Re: **STB Docket No. 42071, Otter Tail Power Company v. The Burlington Northern and Santa Fe Railway Company**

Docket No. 42071

**ERRATA TO THE OCTOBER 8, 2003 REPLY EVIDENCE OF THE BURLINGTON
NORTHERN AND SANTA FE RAILWAY COMPANY**

BNSF REPLY-ERRATA

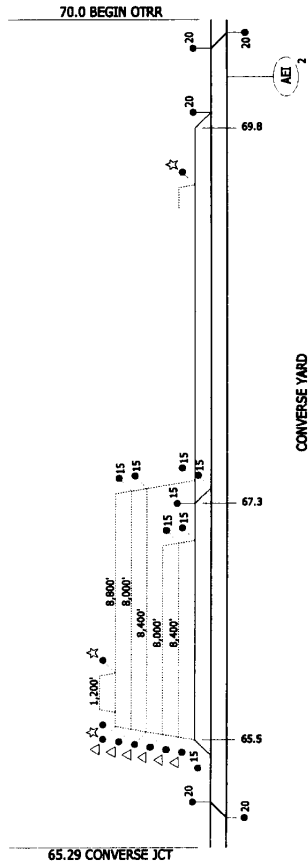
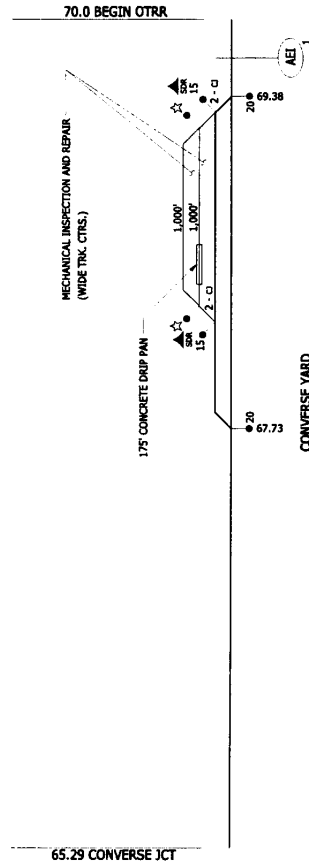
In reviewing BNSF Reply track schematics in Reply Exhibit III.B-1, BNSF Engineering Consultants discovered that the milepost locations for sidings on its Reply schematics differed from the sidings mileposts contained in the RTC model as a result of the assumption of a 15-foot clearance point at the end of the turnout curve, rather than the 14-foot clearance point used in the model. BNSF's track charts were adjusted to correspond to the inputs to the RTC model and, as a result, each end of a siding or double track segment was reduced by .03 miles, and the milepost location of the turnout has been adjusted. The revised total track mile count for the OTRR is 1,768 miles; the total number of route miles has remained the same. The revised breakdown of track miles is contained in Errata electronic workpaper "III B Miles Table_Errata.xls." The reduction in track miles is factored into the total construction costs as restated in BNSF Errata electronic workpaper "III F OTRR Construction_Errata.xls." Errata Exhibit III.B-1, which contains the revised track schematics for the OTRR, is included with this filing as Attachment 1.
